**NOTICE TO CONTRACTORS**  
**BID #1415-028**  
**5<sup>th</sup> Street Pedestrian Improvements**  
**PWP # CC-2014-308**

**Addendum No. 2**

NO.	REVISION	DATE	STANDARD DETAIL FOR PUBLIC WORKS CONSTRUCTION	SECTION CARSON CITY
			<b>PERPENDICULAR CURB RAMP APEX</b>	DRAWING NO. C-5.3.3
				DATE 7/2009
APPROVED BY:		7/09

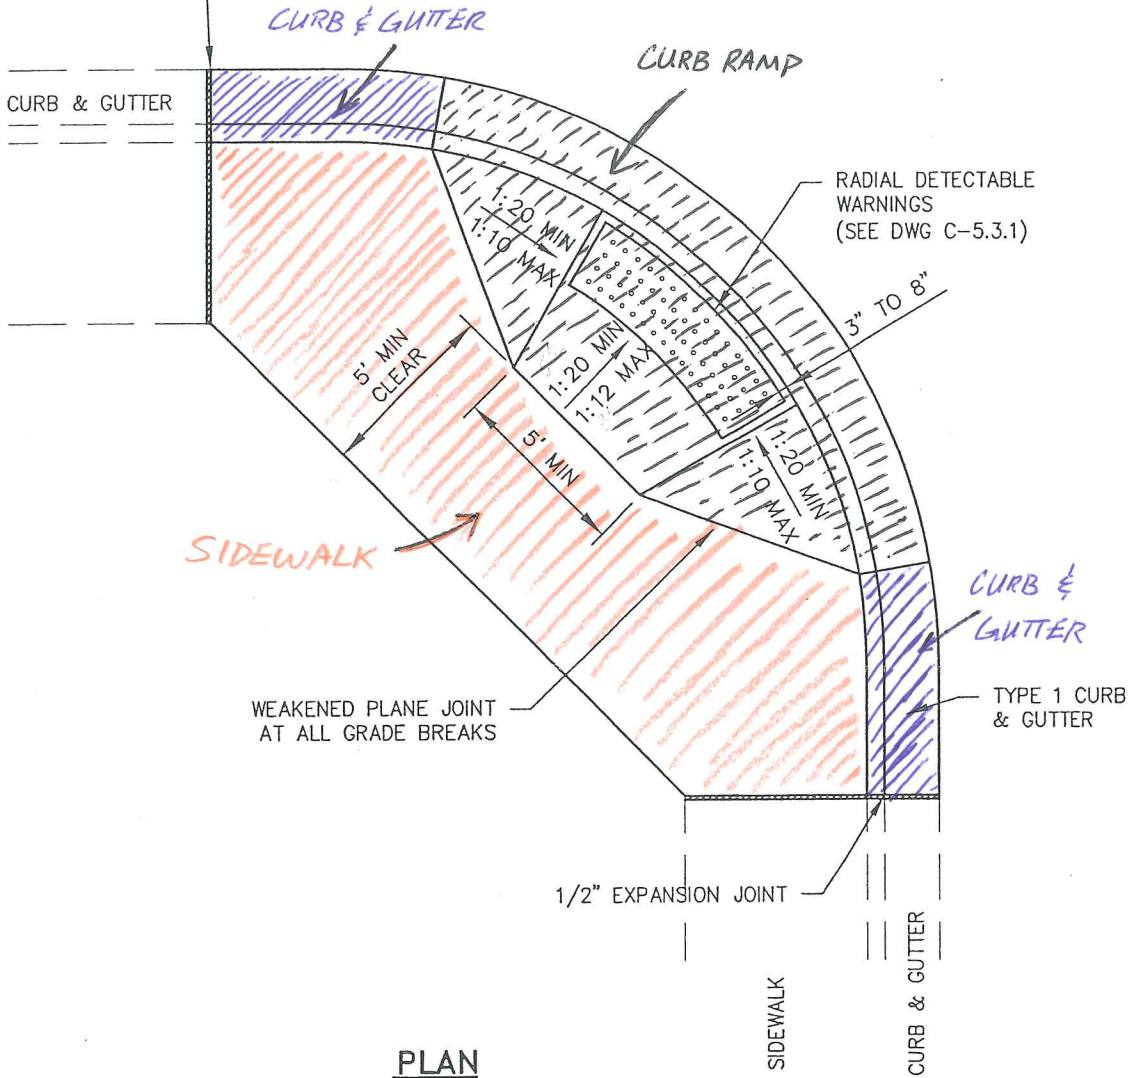
1. *Is the curb and gutter and sidewalk shown with solid lines on the Perpendicular Curb Ramp Apex standard detail C-5.3.3 paid as ramp or as curb and gutter and sidewalk (please see the attachment)?*

See the "Perpendicular Curb Ramp Apex" on the following page for reference on how payment for Curb and Gutter, Sidewalk, and Curb Ramp are to be broken up.
